SERVICE LETTER

No. 186

Piper Aircraft Corporation

SUBJECT: Clearance between the Engine Mount and the Exhaust Tail Pipe and
Clearance in the Nose Wheel Steering Mechanism

Sketch for Service Letter No. 186

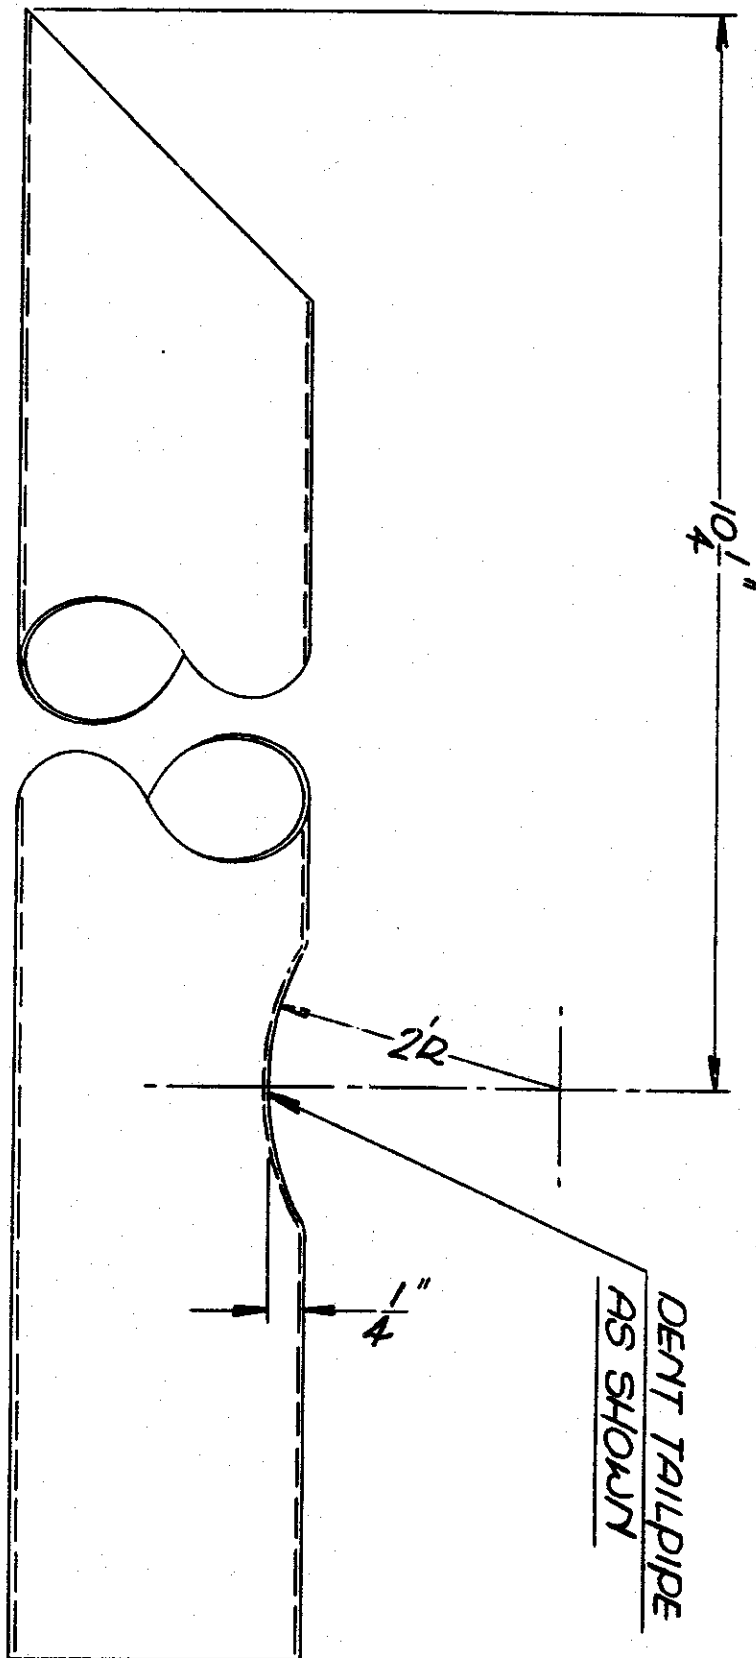
It has been brought to our attention that the clearance between the engine mount and the tail pipe on the subject model airplane is not adequate and in some cases the tail pipe has rubbed the diagonal motor mount tube causing the tube to become somewhat grooved, due to the rubbing and scrubbing action of the tail pipe.

It is requested that an inspection be conducted on all model PA-22 airplanes to ascertain whether or not this condition exists. If at the present time there is no sign of the tail pipe rubbing the motor mount tube it will not be necessary to make any adjustments, however if there are indications that this rubbing action has been taking place then it will be necessary to move the tail pipe location forward, by means of changing or adjusting the tail pipe braces. The clearance between the motor mount and the tail pipe brace should be approximately 3/8 inch. If there has been damage to the motor mount tube in that area it will be necessary to weld an outside sleeve reinforcement in accordance to C. A. A. Manual 18.

When moving the tail pipe forward to provide adequate clearance, there may be slight confliction between the tail pipe and the bottom engine cowl, in which event it will be necessary to cut out a small portion of the cowl.

In the event it is impossible to obtain the proper clearance then the tail pipe should be modified in accordance with the attached sketch.

It has been reported that there have been cases of interference between the cross-over exhaust stacks and the nose wheel steering rod ends. We suggest that you investigate the possibility of this condition existing in your airplane and take corrective action if necessary. Proper clearances can be obtained by denting the exhaust stack tubes at the points of contact by using the same steps and dimensions as shown in the tail pipe sketch.
